Service Bulletin

NO. 325

SOUTH BEND 27, INDIANA

*Studebaker and
Packard Clipper*

Fig. 2

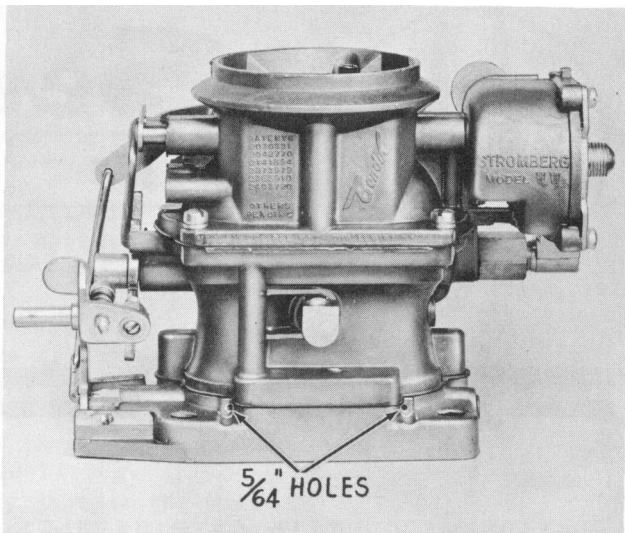
1. Remove the carburetor air chamber cover and remove the carburetor from the engine.
2. Drill a $\frac{7}{64}$ " hole into the vent passage at the location shown in Fig. 1. Then, drill two $\frac{5}{64}$ " holes in the throttle body at the locations shown in Fig. 2. It is not necessary to disassemble the carburetor to drill the holes but care should be taken to prevent chips from entering the carburetor.
3. If the air chamber cover does not have a

Fig. 3

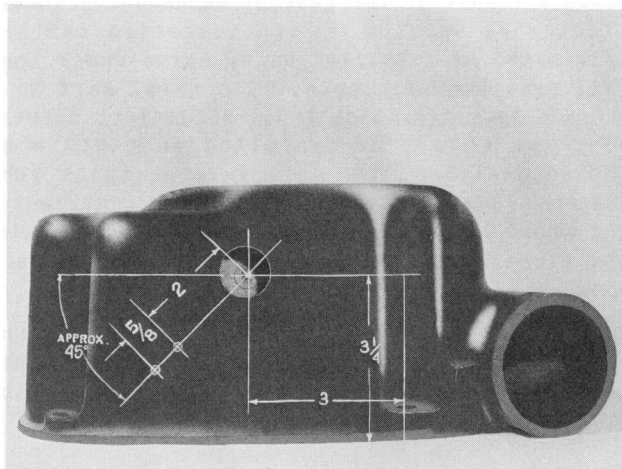
Vent valve (flapper valve) locate and drill a 1" hole and two $\frac{5}{32}$ " holes in the air chamber cover at the locations shown in Fig. 3. Install the Air Chamber Vent Valve Assembly, Part No. 1542765 in the cover (see Fig. 4), placing two small flat washers be-

Fig. 4

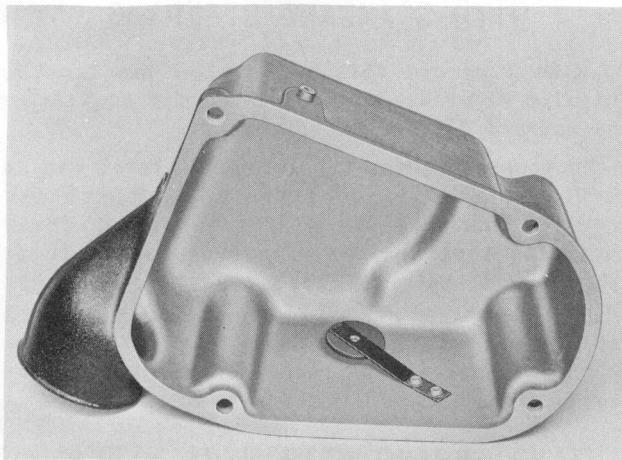
tween the spring and the cover and using two self-tapping screws, Part no. G453113. After the valve is installed, bend the spring as required to obtain an opening of 1/4" between the cover and the highest point at the outer edge of the valve.

Fig. 5

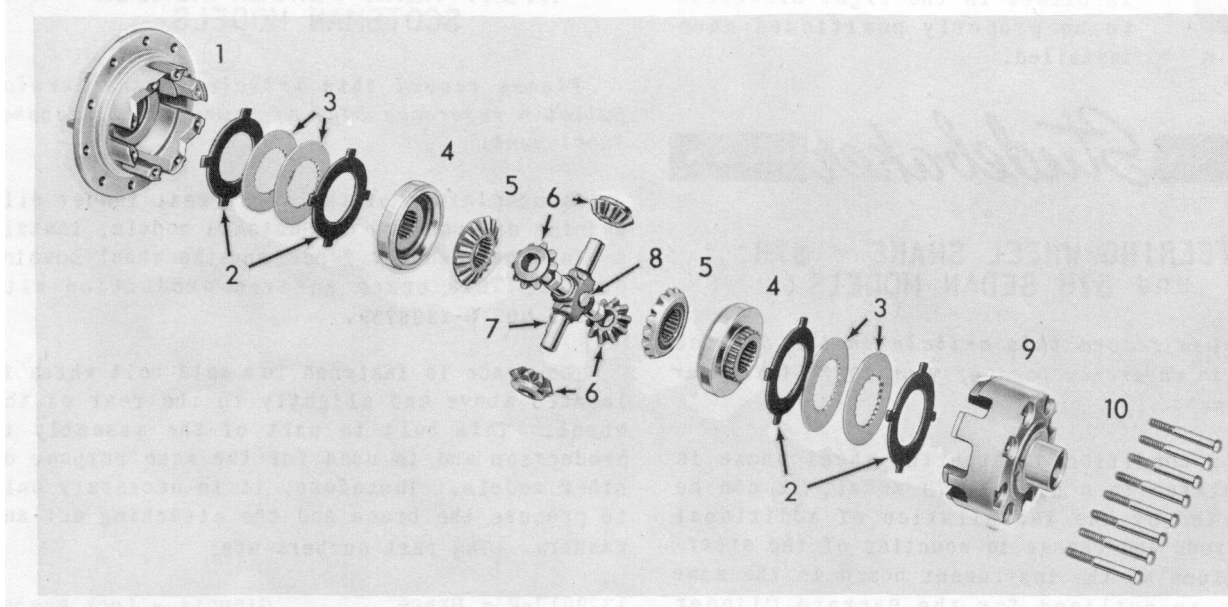
A change has been made in the Twin-Traction differential; the cone-type clutches have been replaced by disc-type clutches. Fig. 5 illustrates the exploded view of the latest type.

The disassembly and reassembly procedure with the exception of the clutches is the same for both types. When reassembling the disc type, the lugs of the plates are placed in the notches provided in the housing. Note the relationship of the discs to the plates; the two friction discs are placed between the plates.

Fig. 7

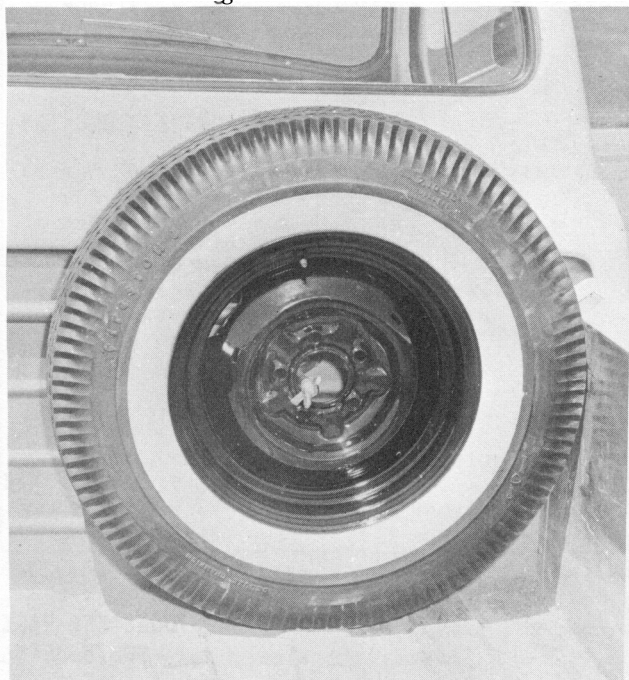
Recently a new location for the spare tire was released as a factory installed option for trucks equipped with a pickup body. At the optional location, the tire is mounted at the front wall of the body (see Fig. 7). This can very readily be adapted to prior models for owners desiring this "in the box" location.

Fig. 8

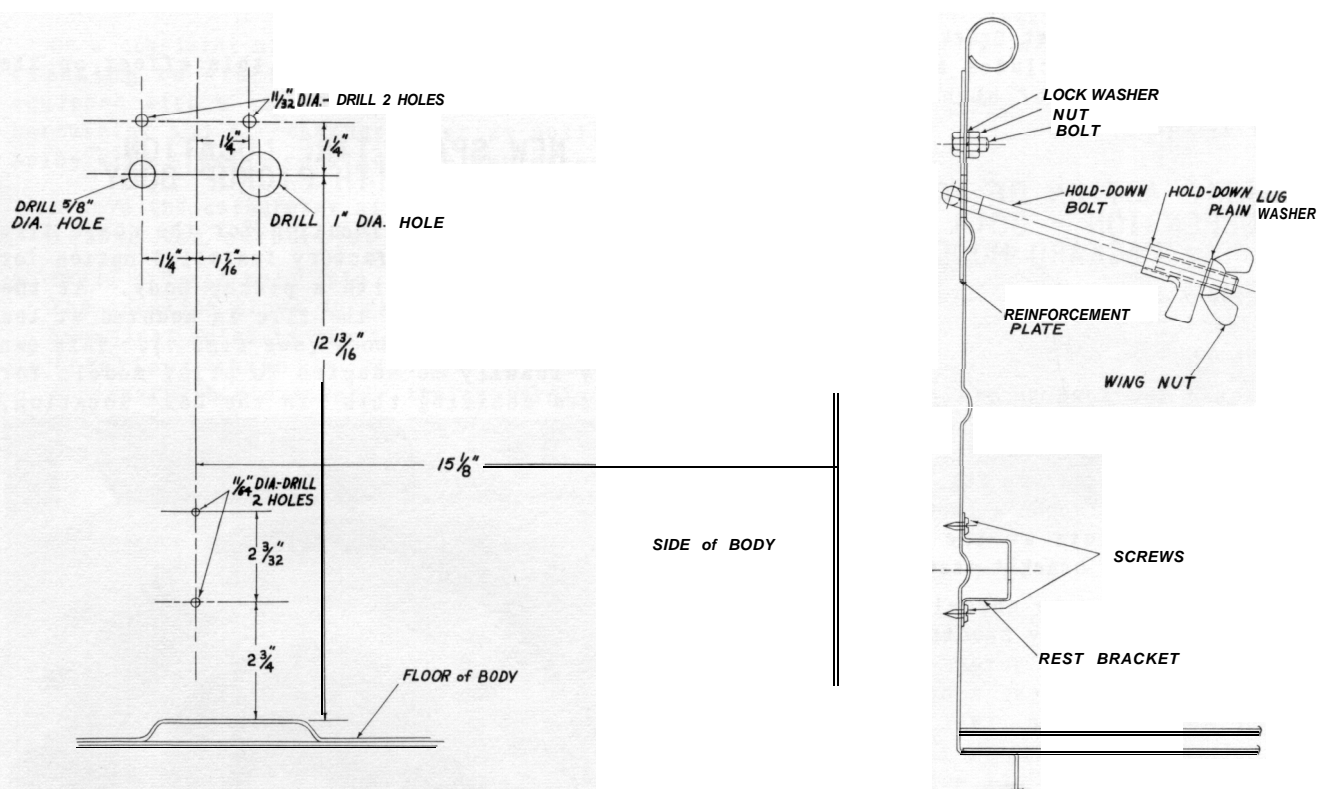
Drill the front wall of the pickup body at the locations indicated in Fig. 8. Install the reinforcement plate and install the hold-down bolt in the lower set of holes. Drill two holes for the rest bracket retaining screws at the locations shown in Fig. 8 and install the bracket.
